Responses to CEC Data Requests Set Two: Nos. A124 through A180

Amended Application for Certification
for
HYDROGEN ENERGY CALIFORNIA
(08-AFC-8A)
Kern County, California

**RESPONSES TO DATA REQUESTS A124 THROUGH A180
FROM CALIFORNIA ENERGY COMMISSION (CEC)**

FIGURE A124-1

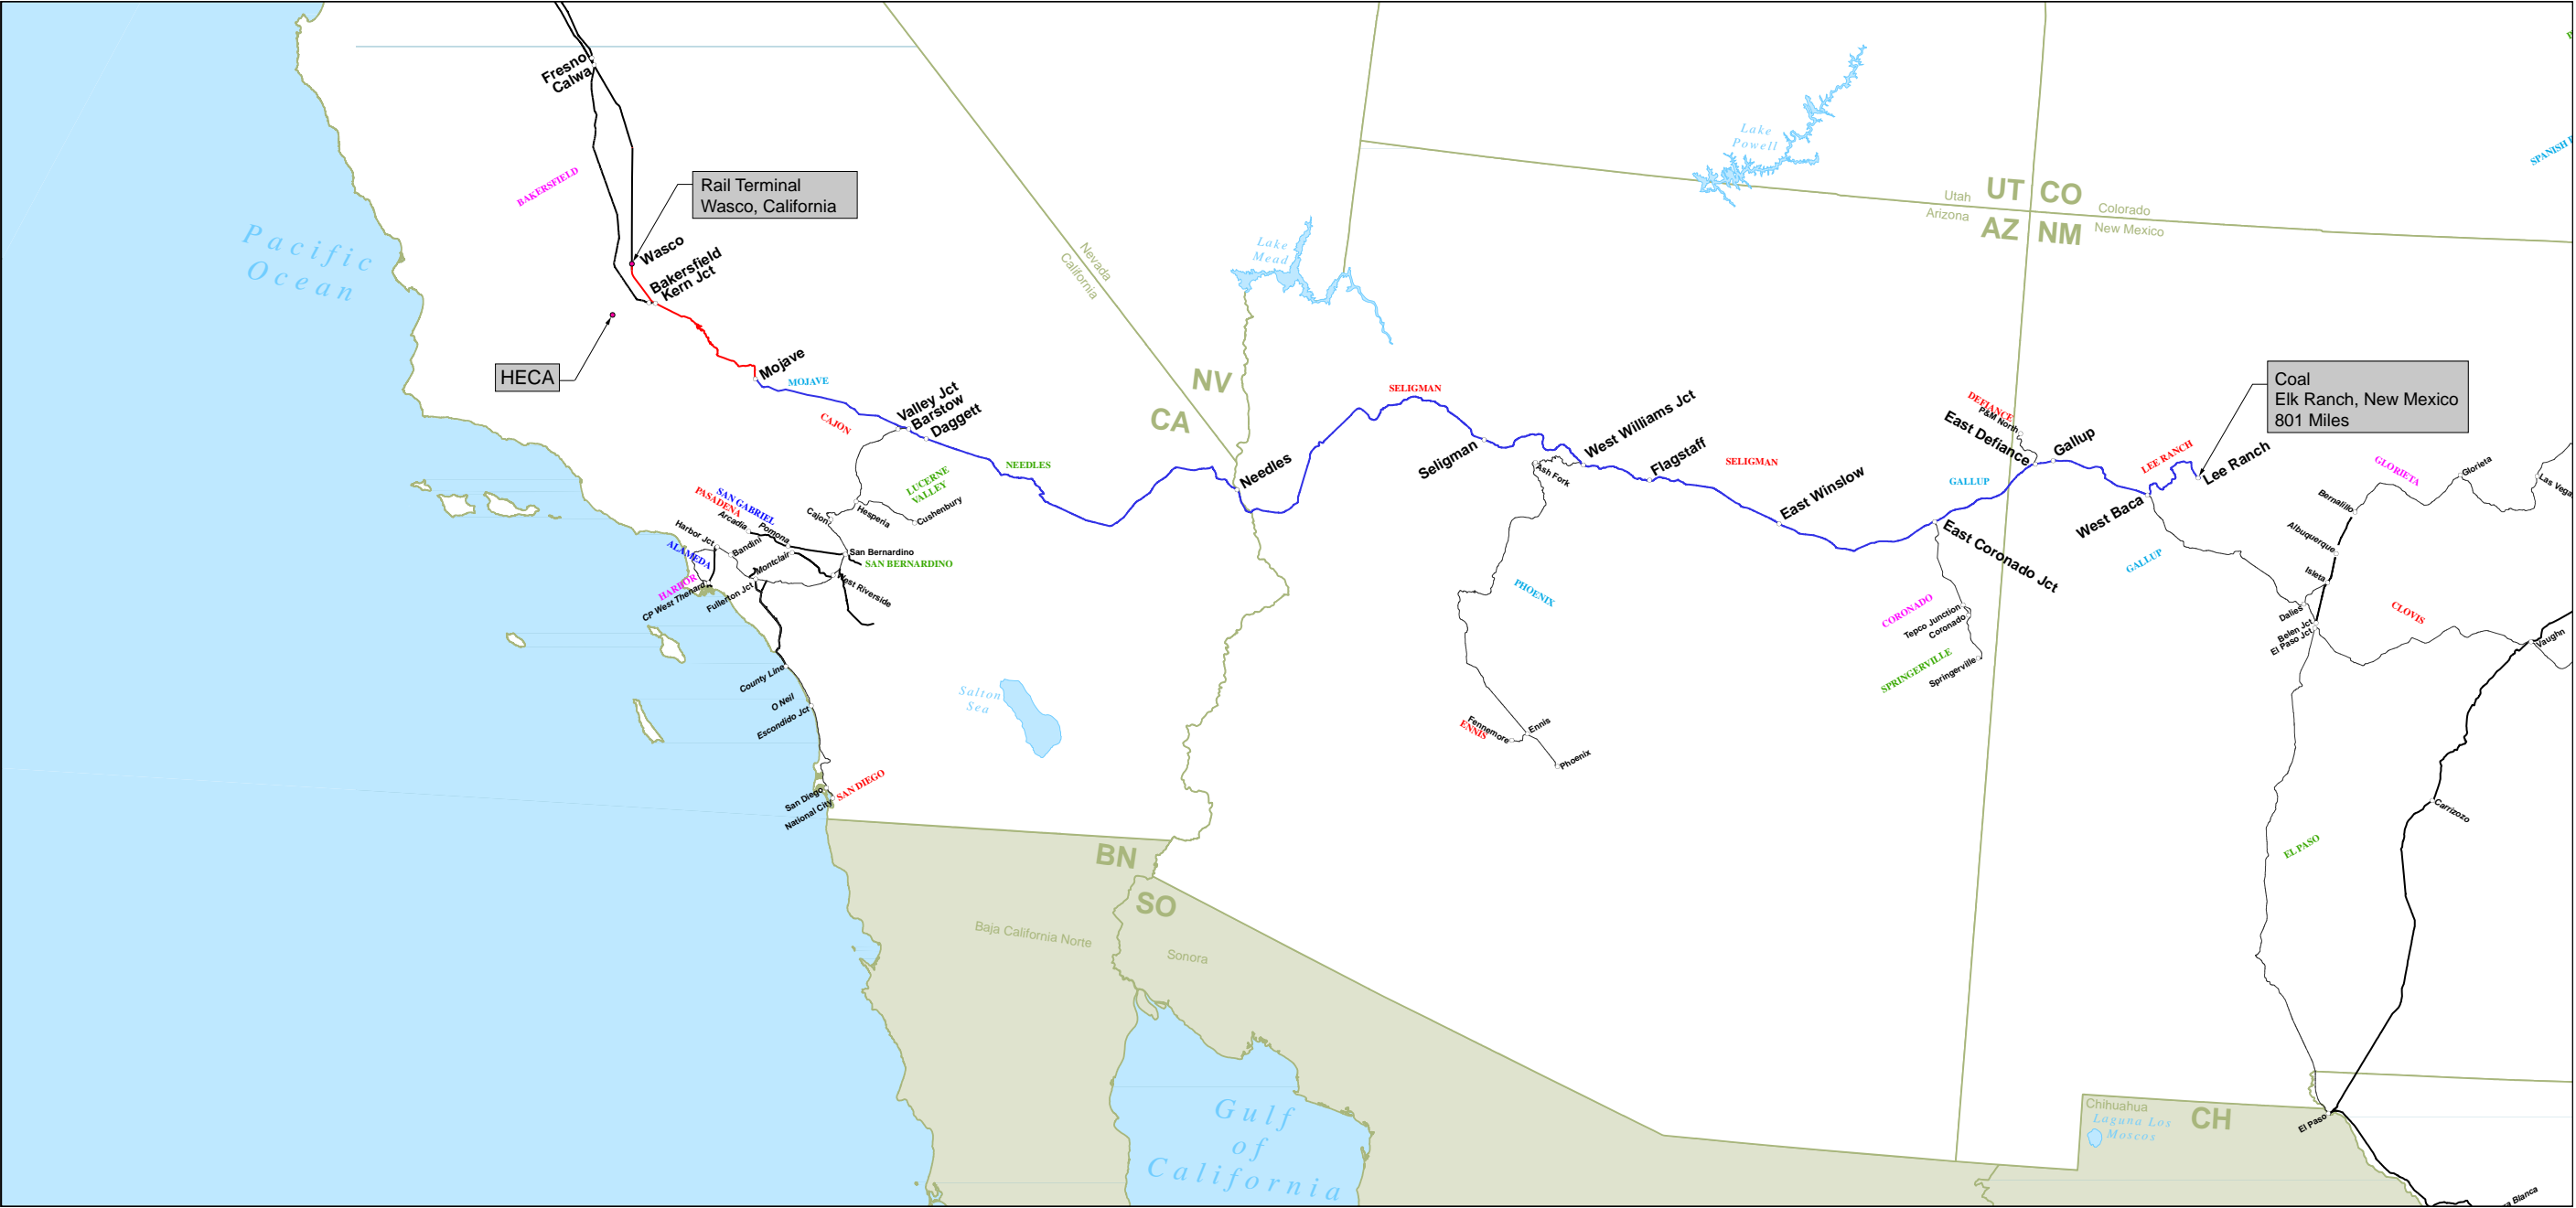
A124. Please provide a route map or a detailed description of the rail routes for coal feedstock delivery and product delivery, for both project alternatives, and describe any corrections to the jurisdiction segment and total rail route lengths.

Figures A124-1 and A124-2 present the delivery routes for Alternative 1 (rail transportation) and Alternative 2 (truck transportation). The response to Data Request A125 clarifies the jurisdiction segments and rail lengths.

FIGURE A149-1 - SHEET 1

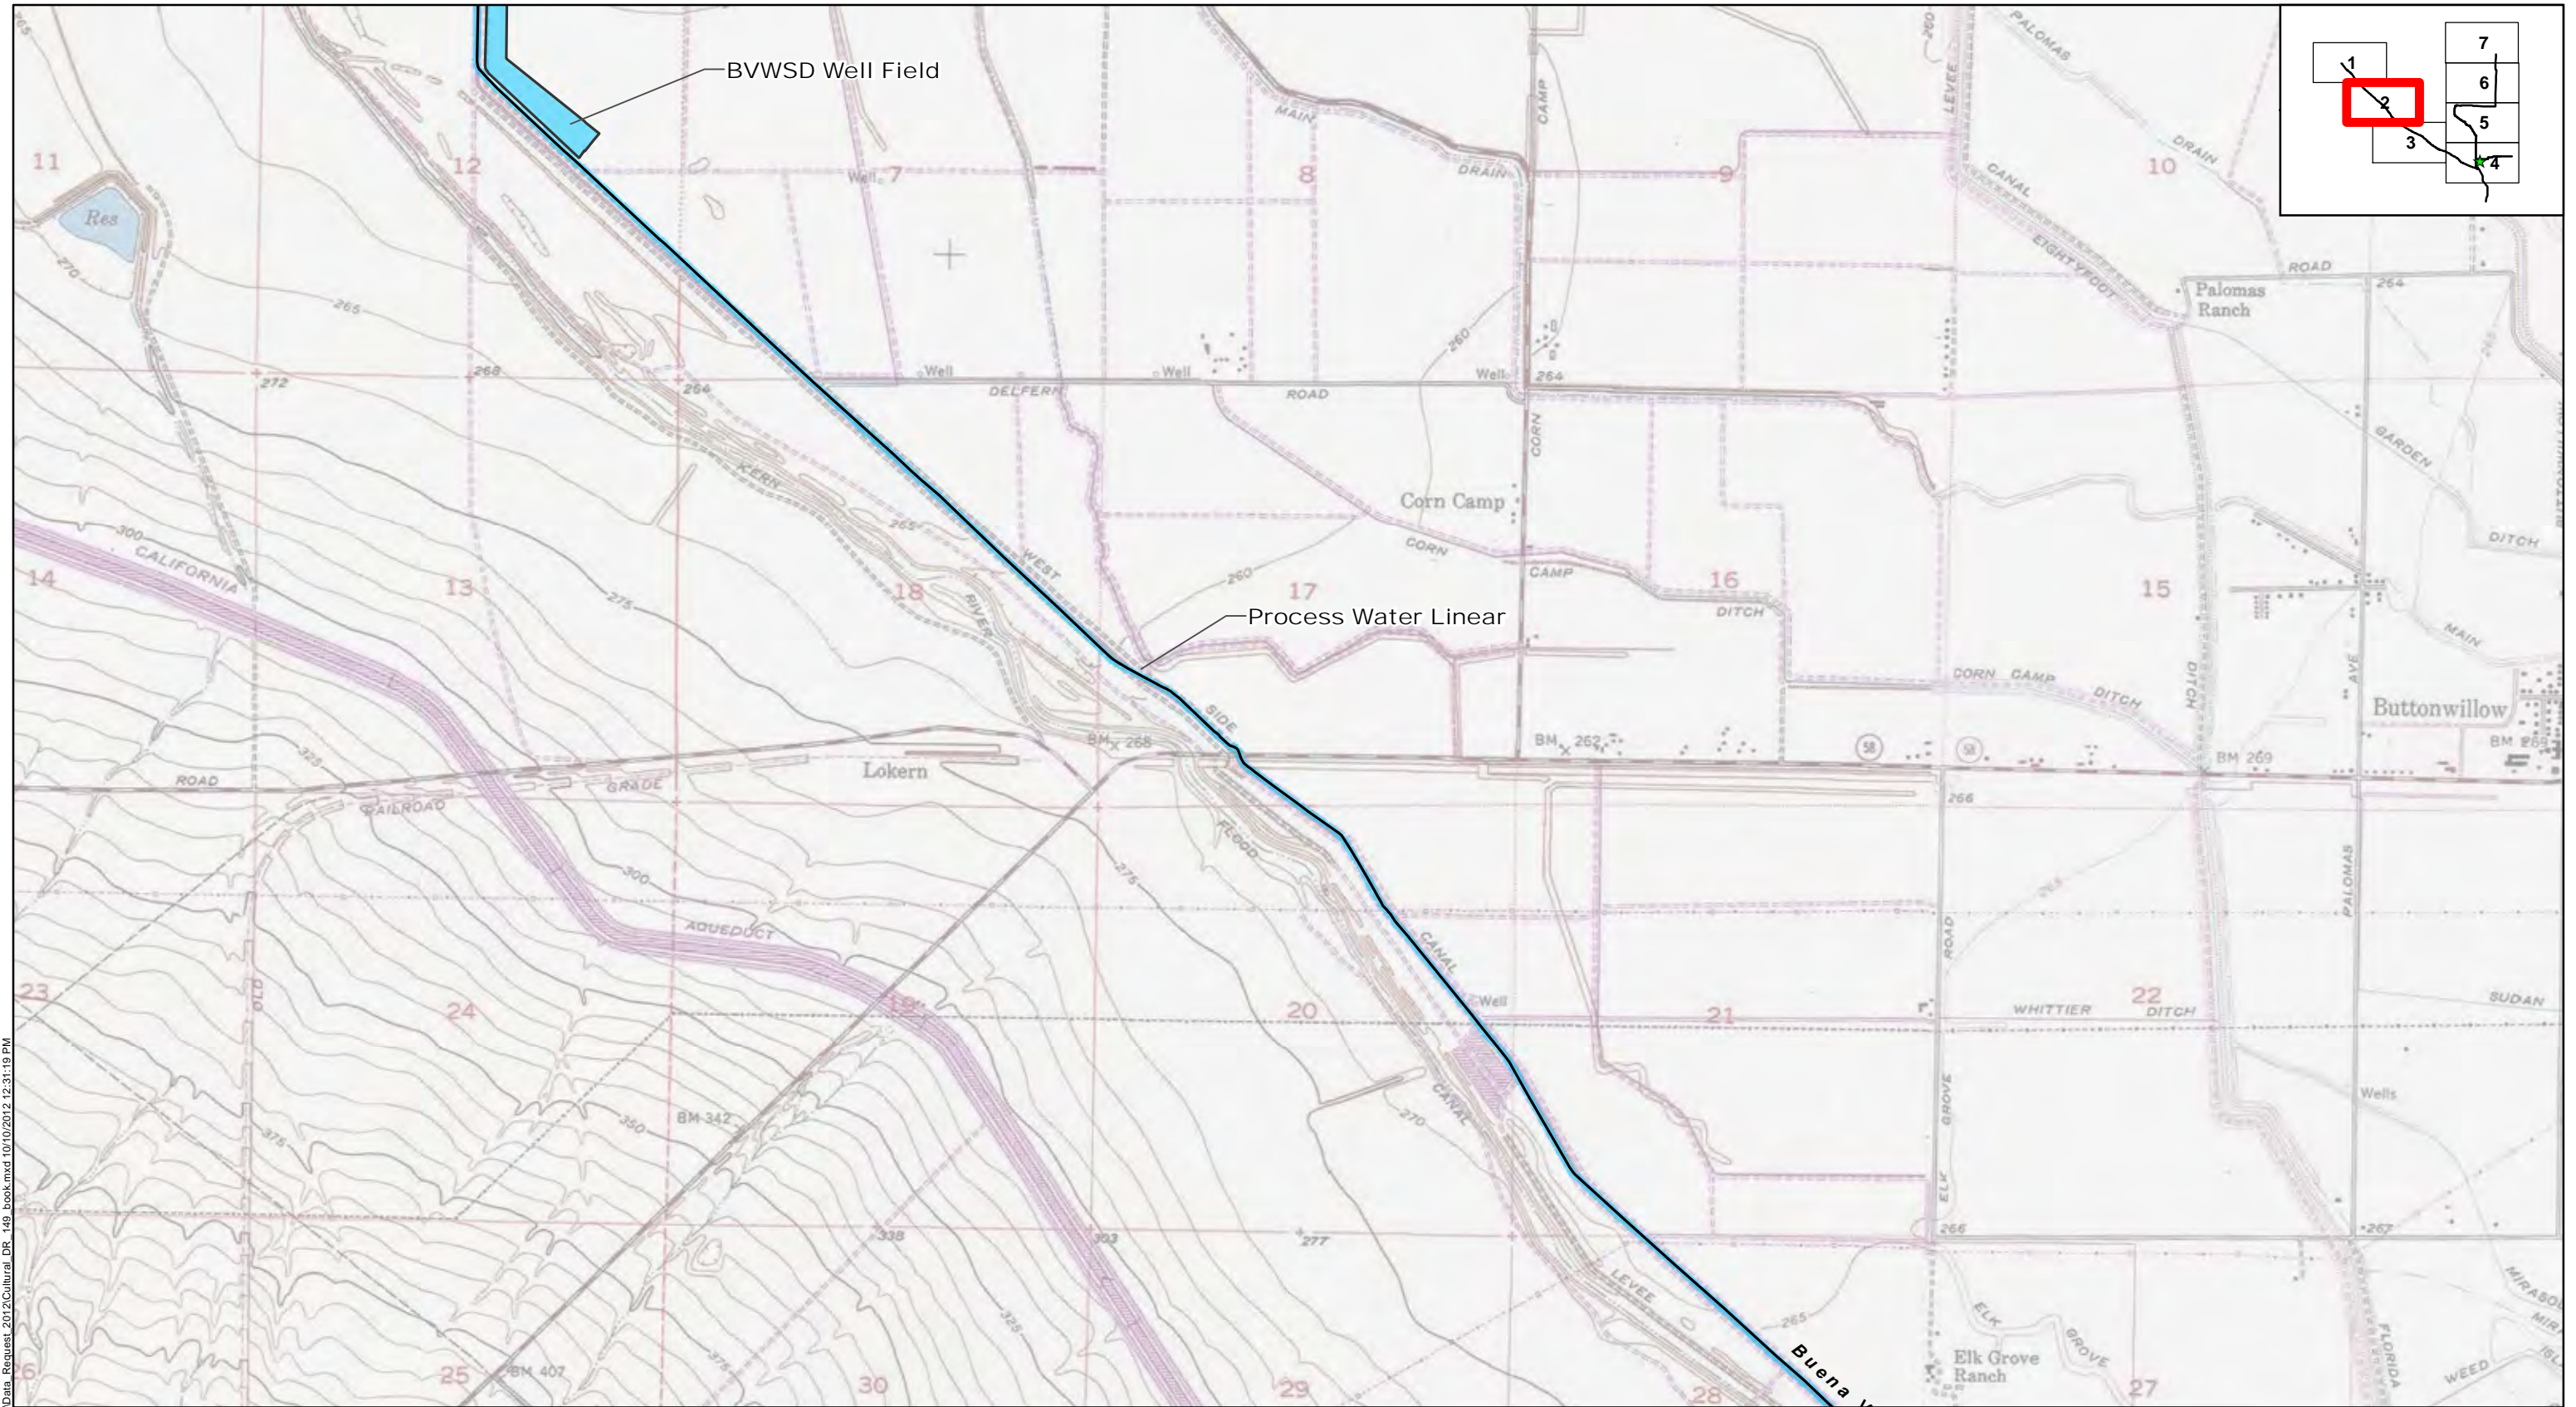
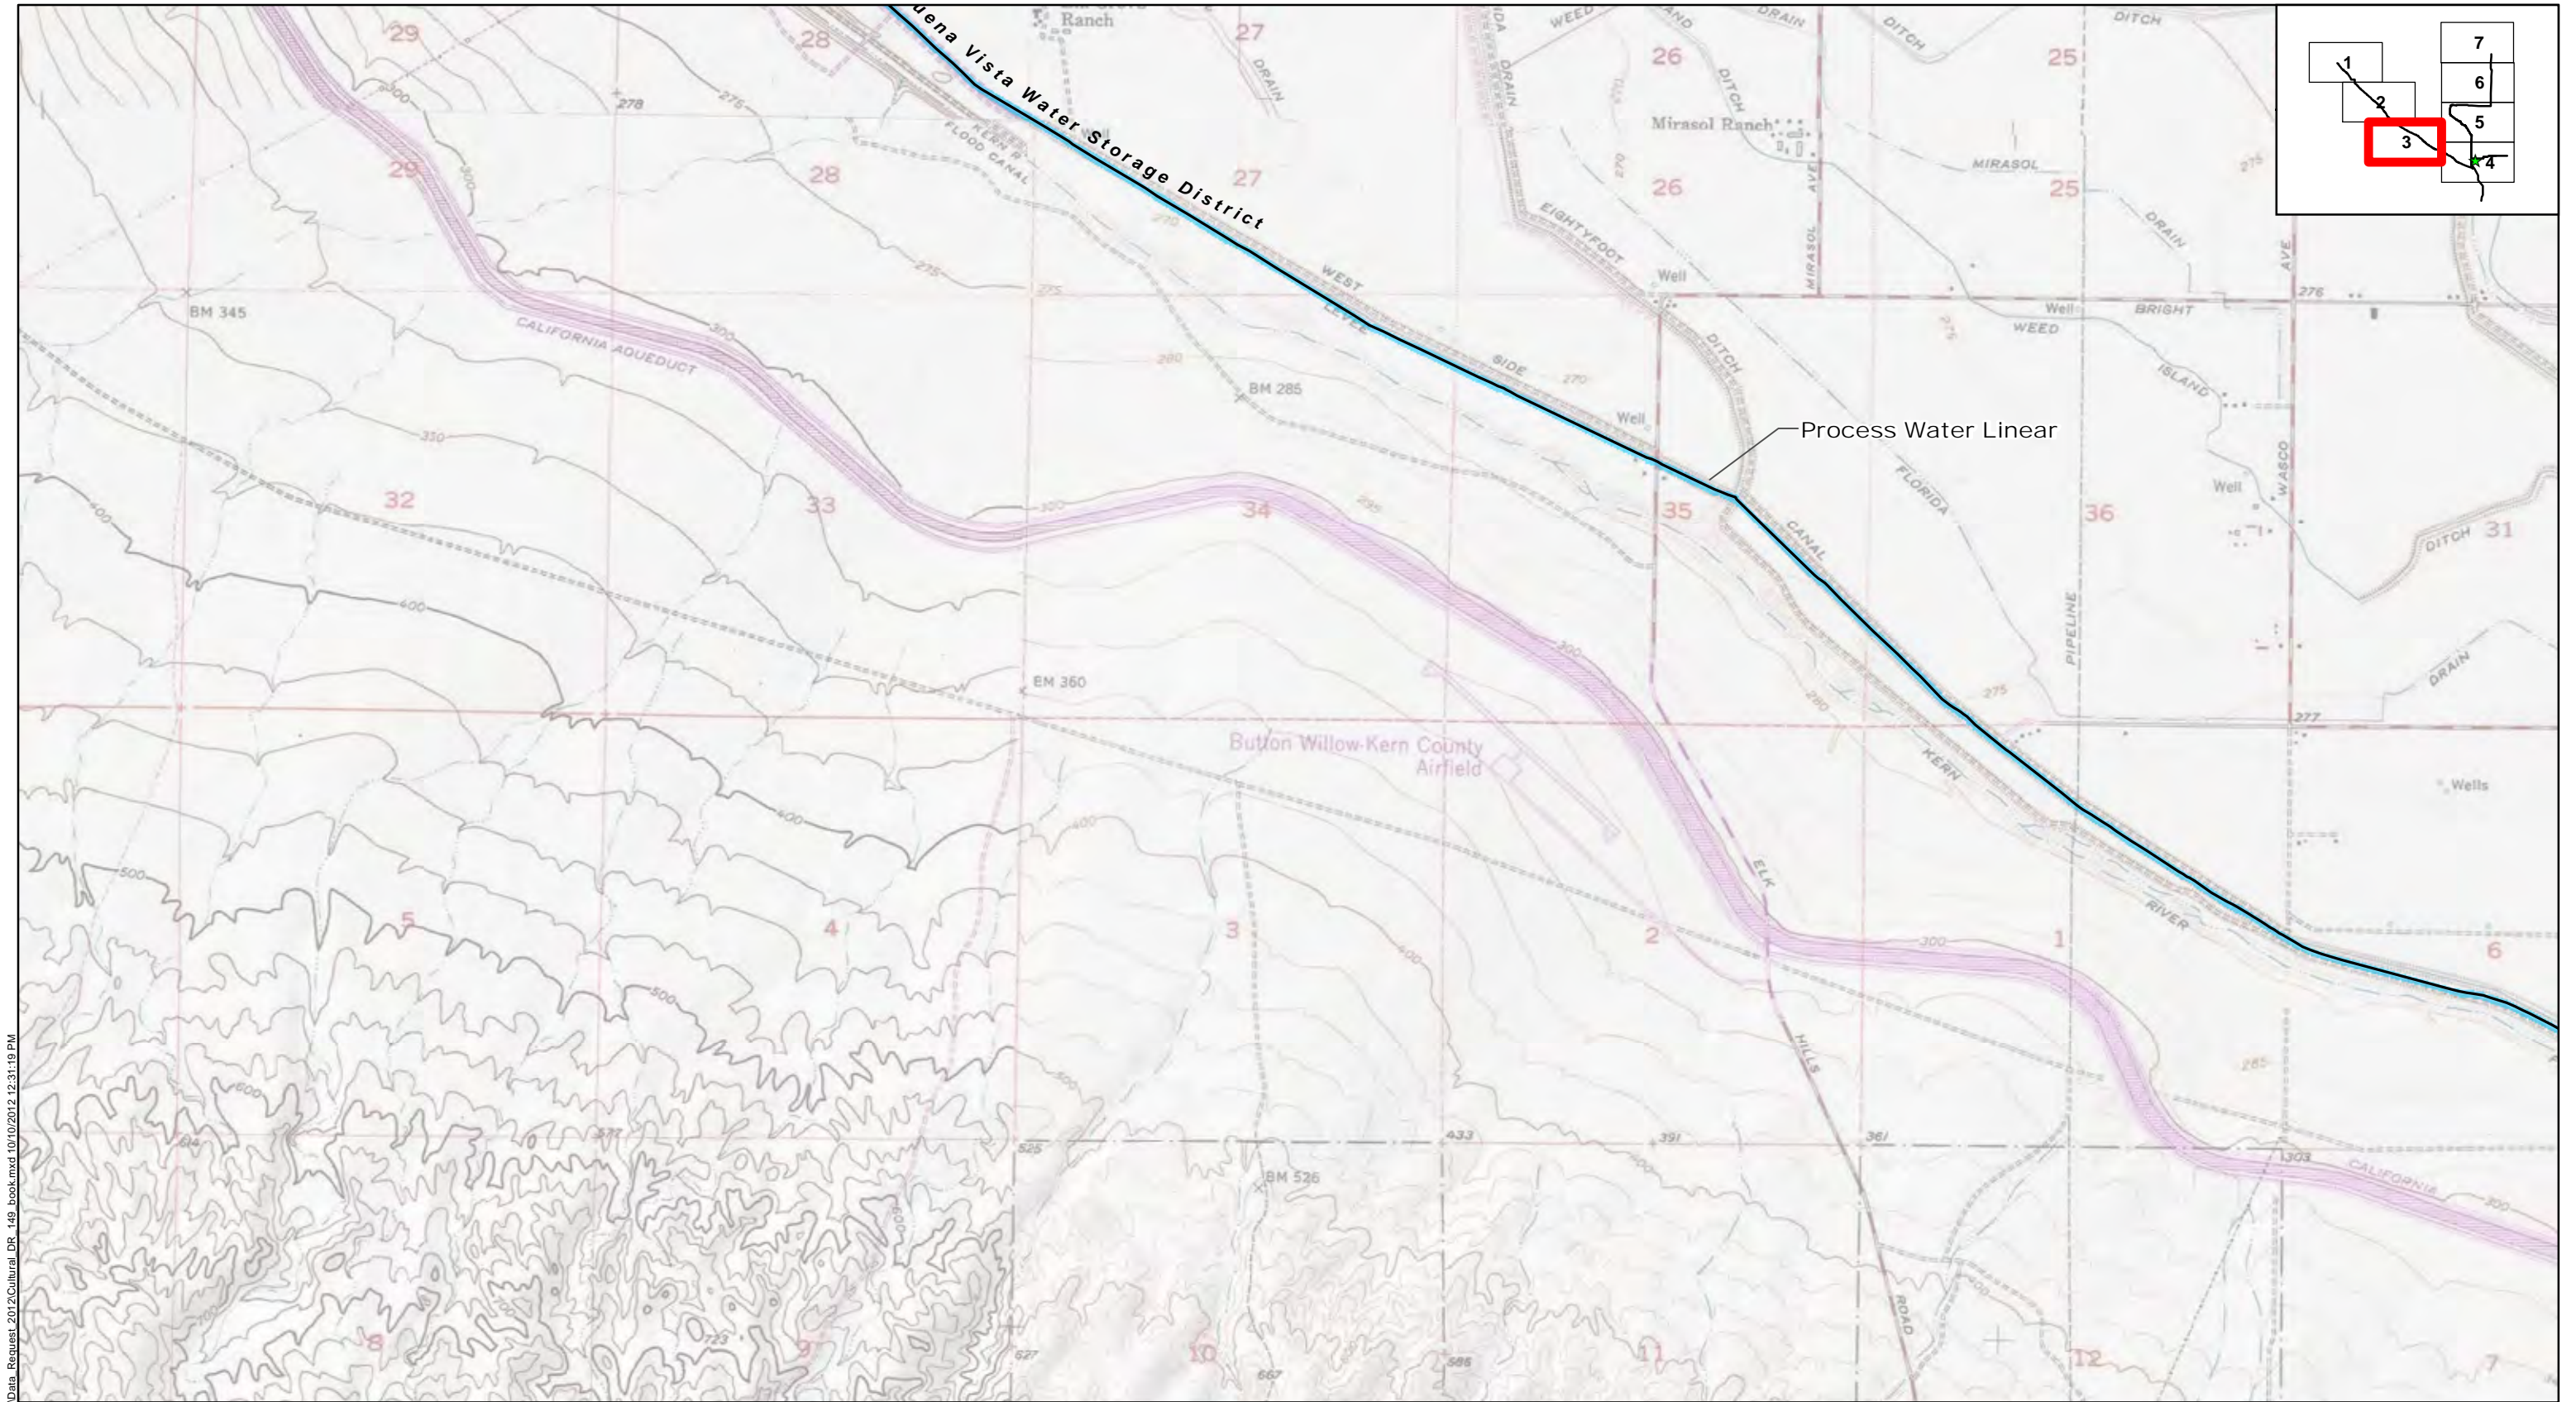
A149. Please provide survey coverage figures on a 7.5-minute topographic quadrangle base (set at 7.5-minute scale). The figures must include all project elements and boundaries of the areas actually surveyed.

A map set depicting all survey coverage on 7.5-minute topographic quadrangles has been prepared, and is presented on Figure A149-1.
